**STATE OF VERMONT
PUBLIC UTILITY COMMISSION**

Case No. 21-2939-NMP

**FIRST SET OF INFORMATION REQUESTS SERVED UPON
AGENCY OF AGRICULTURE, FOOD, AND MARKETS BY
INTERVENORS MICHAEL BINDER AND JOAN ALLEN**

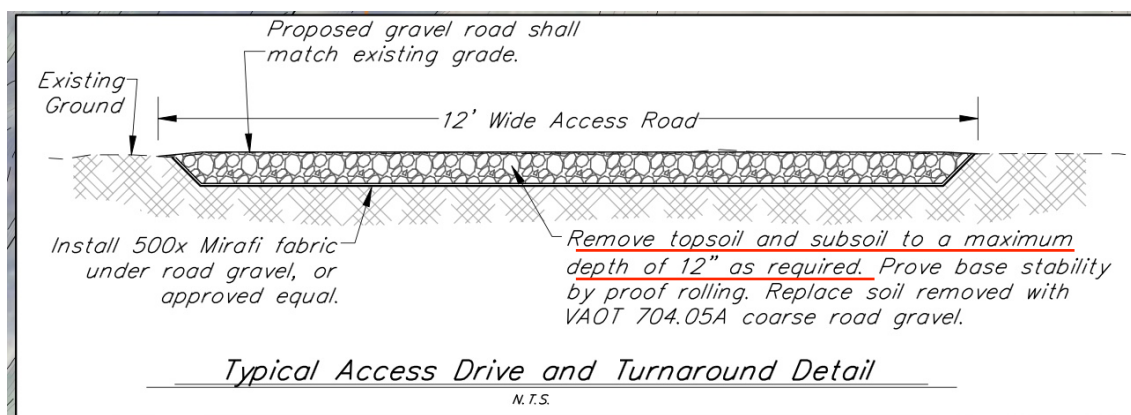
Please pretend the project site is flat, and that the Access Road Cross Section in the Site Plan (Figure 1) is a typical cross section of the proposed road.

Note that in Figure 1, PAS is removed to a maximum depth of 12 inches. If the excavation turns out to be less than 12 inches, the volume of the PAS would (of course) be less than 4800 cubic feet. In order for the PAS to fit in a 10 ft x 60 ft PAS Storage Area with a 2:1 embankment slope, the depth of excavation of the 12 ft wide road would have to be less than 2 inches. If the excavation of PAS is greater than 2 inches, the PAS Storage Area is undersized.

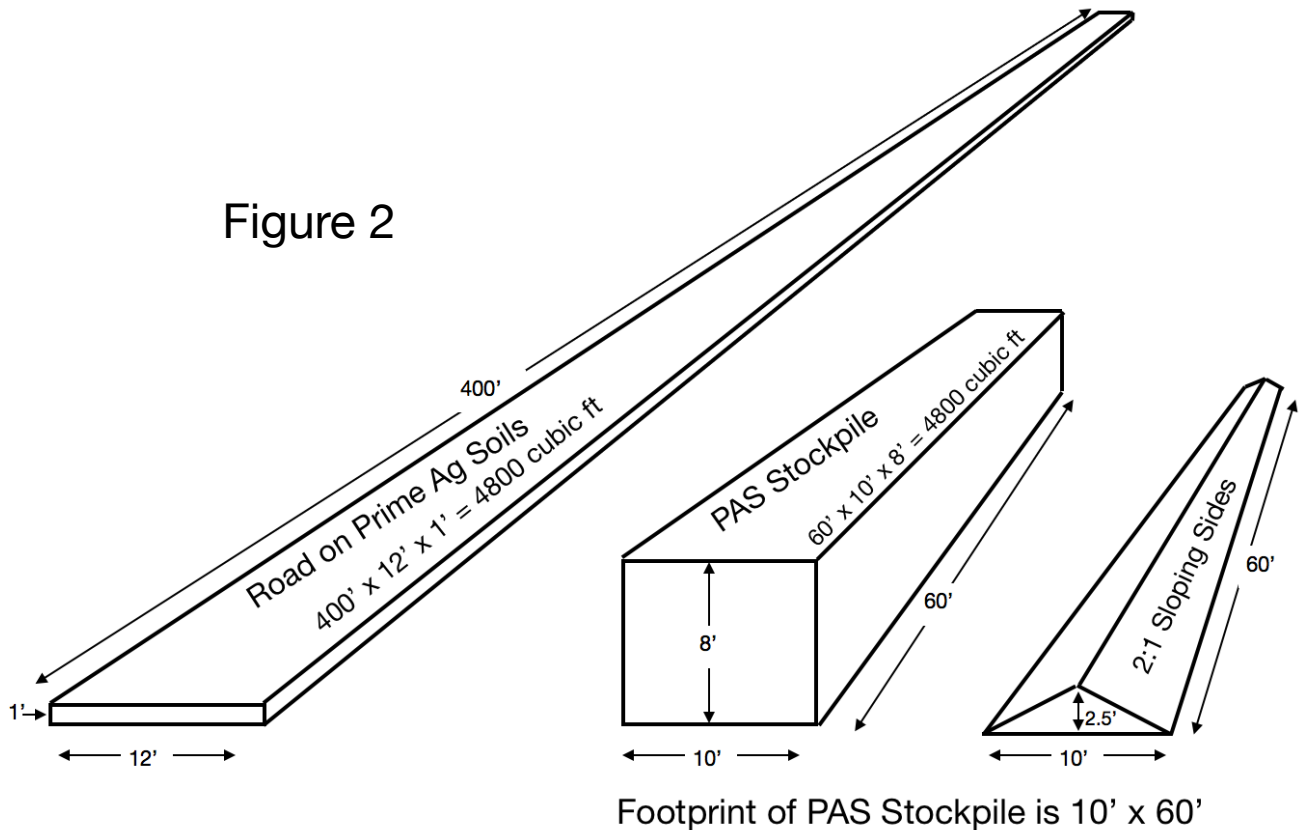
The Site Plan (see Figure 3) shows that a 400 ft stretch of the Access Road is on Buckland Prime Agricultural Soils (PAS). If 12 inches of PAS were scooped out of the road bed as described in Figure 1, the volume of the PAS would be 4800 cubic feet (see Figure 2).

As can be seen in Figure 2, The amount of PAS removed from the Access Road would fill a rectangular solid measuring 10 ft wide, 8 ft high, and 60 ft long. Of course, soil embankments must be sloped. An embankment with a 2:1 slope is also depicted in Figure 2, and its capacity on a 10' x 60 ft footprint is less than 750 cubic ft.

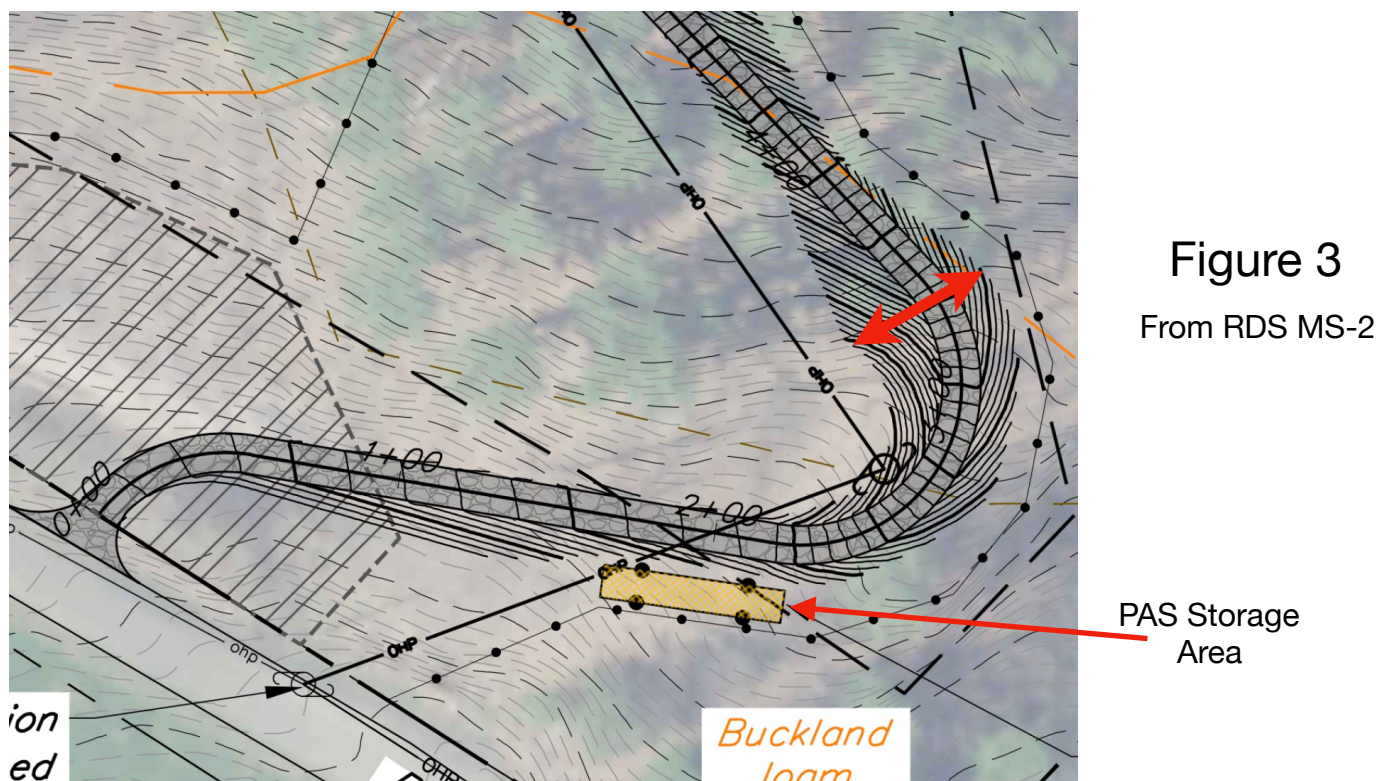
The Thought Experiment is concluded. The Access Road is not on flat land and the cross section in the Site Plan (Figure 1) is very misleading. The proposed road is actually on very steep slopes and it will require extensive cutting and filling. Figure 3 is a detail from the Site Plan and it shows the stretch of the Access Road that is on PAS. Note that the cut & fill is up to 47 ft wide at the double-headed red arrow.

If the procedures outlined in Reclamation Guidelines for Agricultural Soils are followed, the topsoil and subsoil Horizons will be removed, segregated by Horizon, and stockpiled before the cutting and filling may occur. The Buckland PAS that underlies the road typically has 20 to 36 inches of Solum¹ that will have to be removed, segregated into Horizons and stockpiled. If the

excavation cuts into Horizon C which underlies the Solum, that Horizon will also have to be segregated. This is likely where the terrain is steepest and/or the Solum is thinnest (20 inches). The Thought Experiment demonstrated that if the PAS was excavated **just** 2 inches deep over the length and width of **just** the 12 ft wide roadbed, the PAS Storage Area would be undersized. Now it is clear that the depth of excavation of PAS will be at least 20 inches (in a best case scenario) and the area of excavation will be significantly wider (up to 47 ft) than the 12 ft roadbed. The PAS Stockpile Area is likely undersized by two orders of magnitude.

1) Admit that the 10 ft by 60 ft PAS Storage Area shown in the Site Plan cannot hold the volume of PAS that must be excavated.
